Subject: Culvert Installation
Cordata Business Park

RE: Weir for Cordata Business Park

Pegasus Eco-Terrestrial Services
Cordata Weir Construction Plans

SUBJECT: Installation of new weir and culvert at Koll mitigation site (OYB-4-014232)

OUTLET PROFILE
 H. SCALE: 1" = 10'
 V. SCALE: 1" = 5'

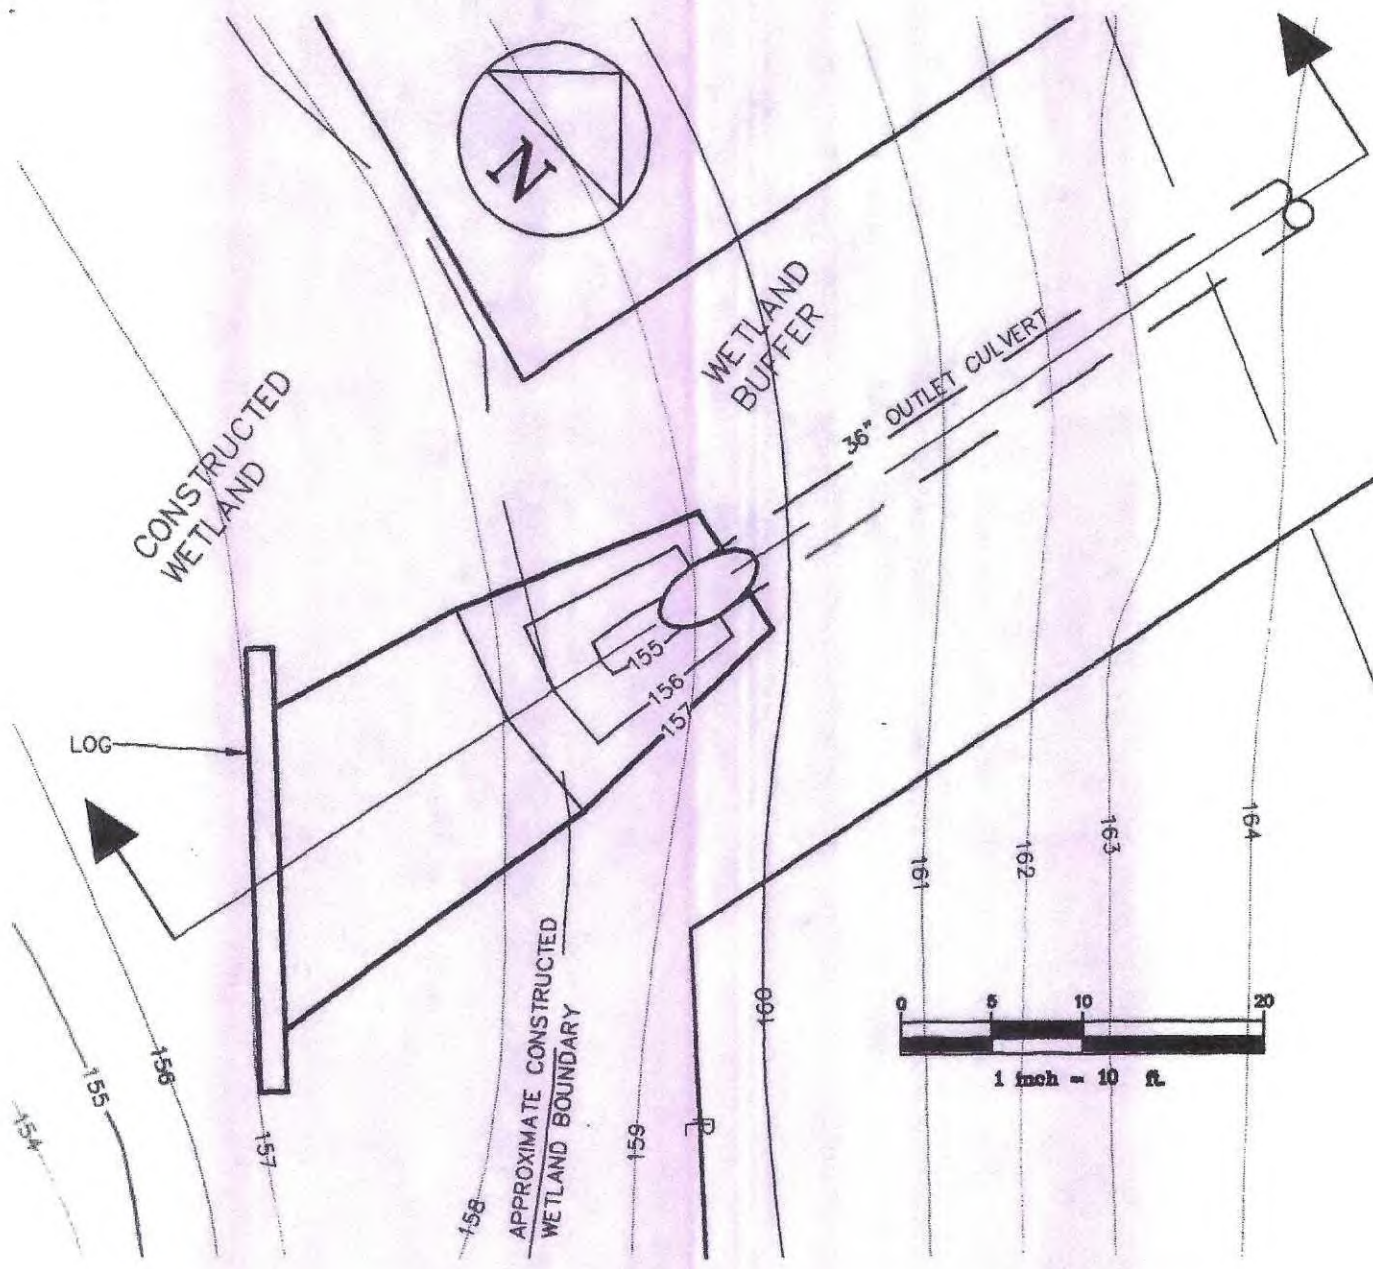
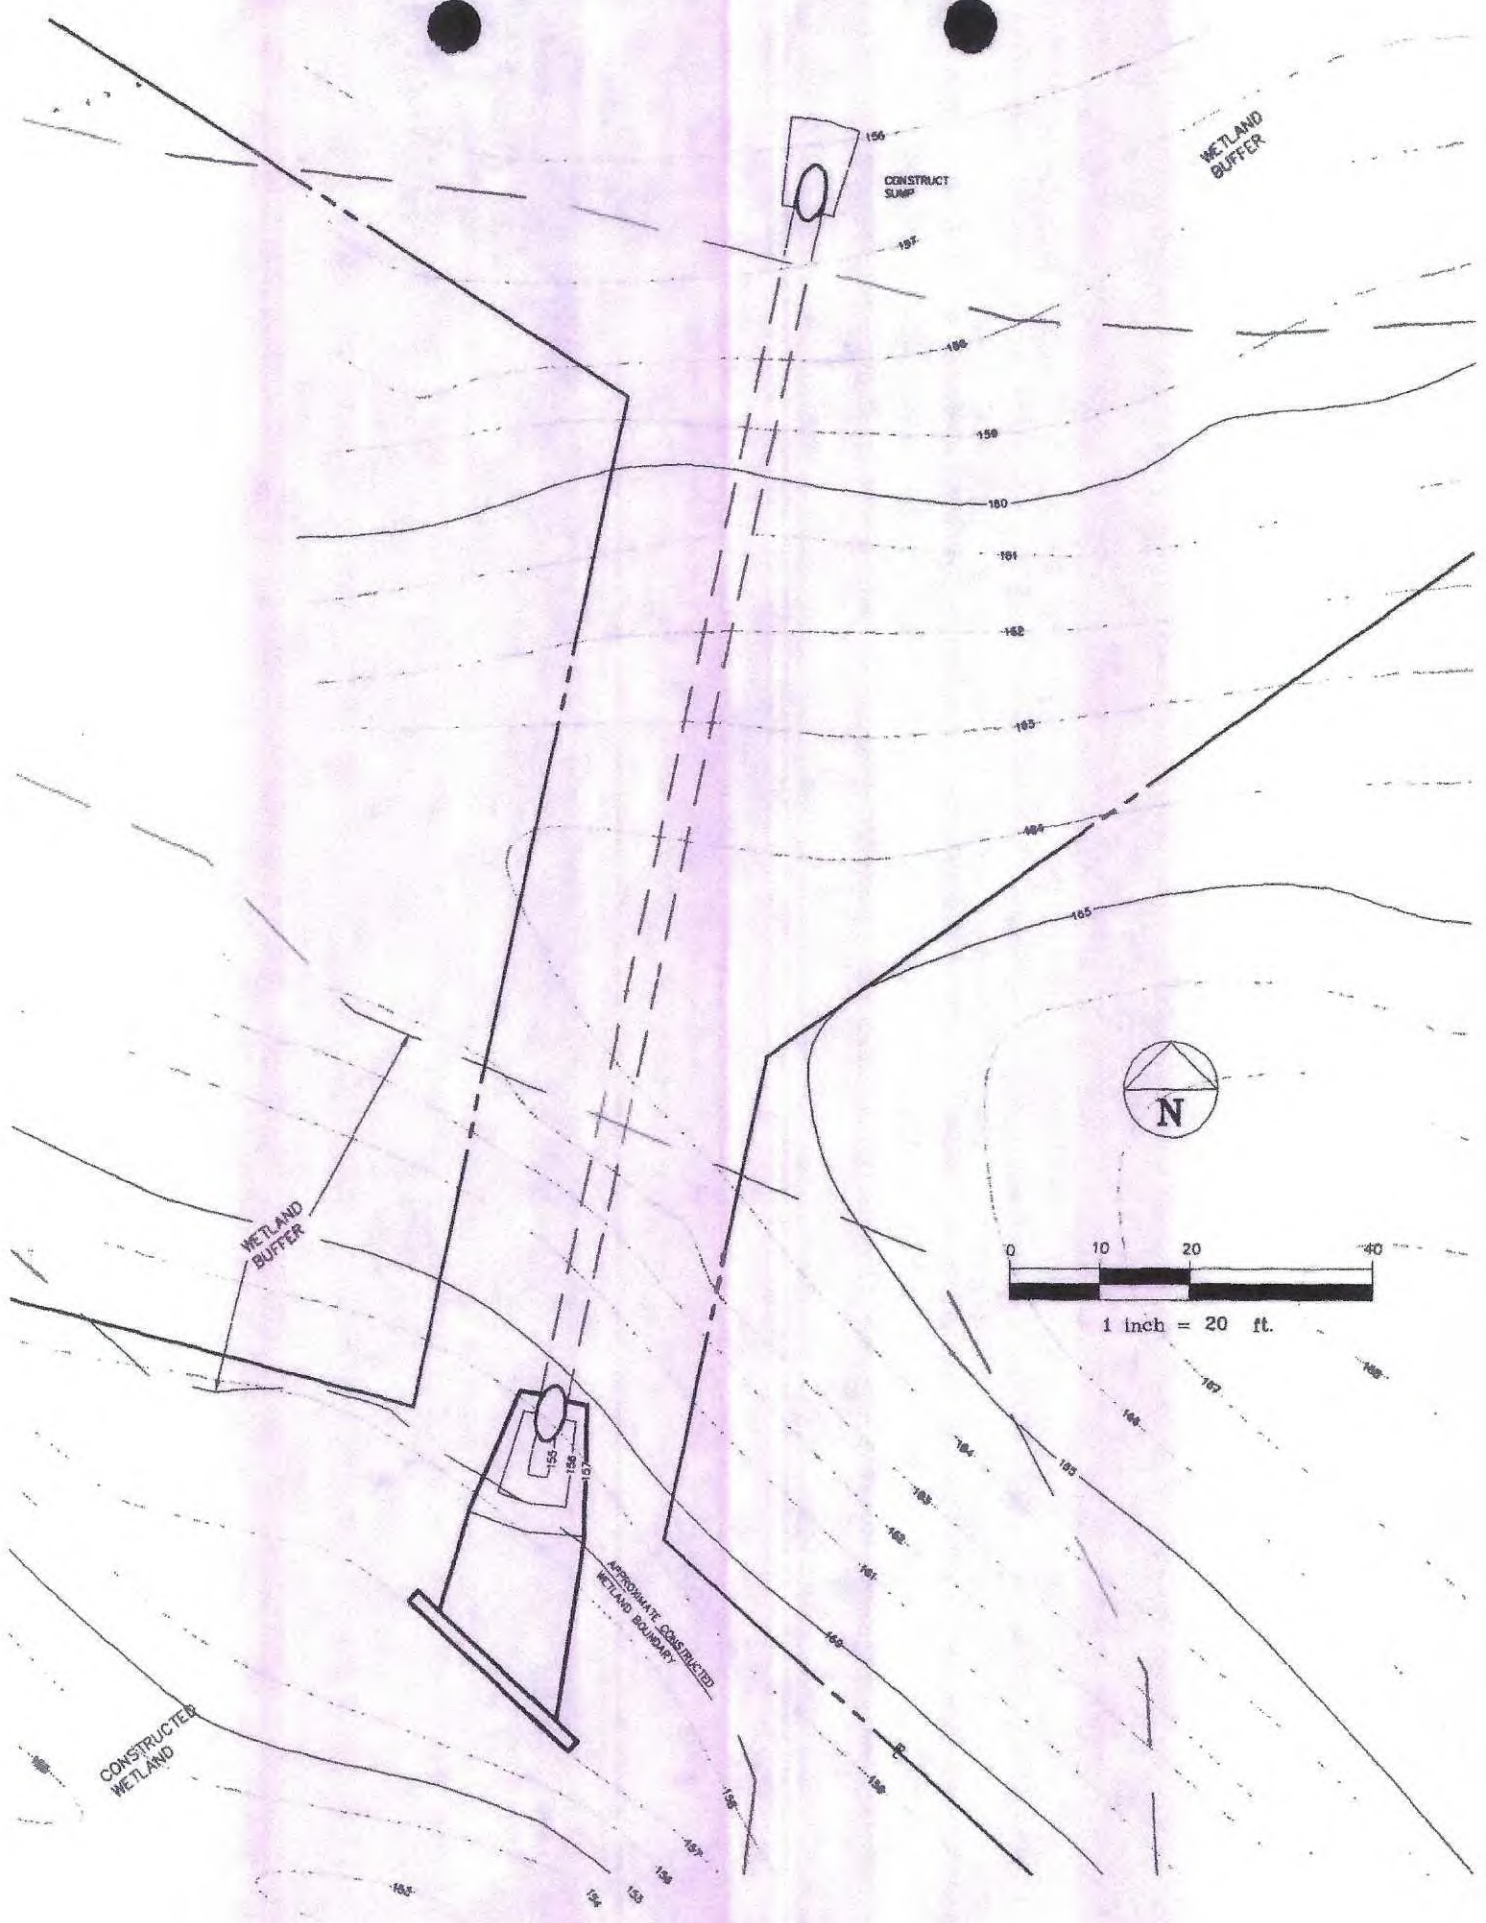
no problem but need in writing new weir will not have impact on required hydrology as planned in mitigation report

How does using same elevations protect/mitigate H₂O - should pass only X case flow to maintain proposed H₂O present?

This letter is sent as the clarification you requested regarding the proposed weir elevation associated with the subject culvert installation project. This project lies north of the large wetland area in the western portion of the Cordata Business Park. To re-iterate, the intent of this project is threefold. First, it is required that runoff leaving developed portions of the basin be detained. To accommodate this goal and provide the required detention, the detention facility located north of Horton Road was sized and constructed for this purpose. The original drainage study for the Cordata Business Park included the conveyance (culvert) in question, providing the necessary conveyance from the developing basin to the now existing detention facility. As you are aware, it is proposed to construct this conveyance at this time. A second goal of this conveyance construction project is to maintain runoff flow to the existing conveyance west of and downstream of the constructed wetland area. Currently, this existing conveyance is fed from a small weir which maintains the water elevation in the wetland area at 157 feet. The third goal of this project is to maintain this water surface elevation so that the wetland area will remain unchanged.

To meet the intent of the original drainage layout, and to accommodate the wetland area constructed since that time, we propose a bypass design which will meet all of these goals. Critical to this design is the placement of a weir, also set at elevation 157, prior to the runoff entering the new conveyance. By placing the weir at this elevation, runoff flow will be split, with some flowing west into the existing conveyance, and some flowing north through the new culvert to the detention facility. As a result of this design, as runoff increases (from a storm falling on a developed basin) more water will flow to the north than to the west. This will allow detention of the larger storm events, will maintain flow into the existing conveyance, and will leave the water surface elevation of the wetland area unchanged.
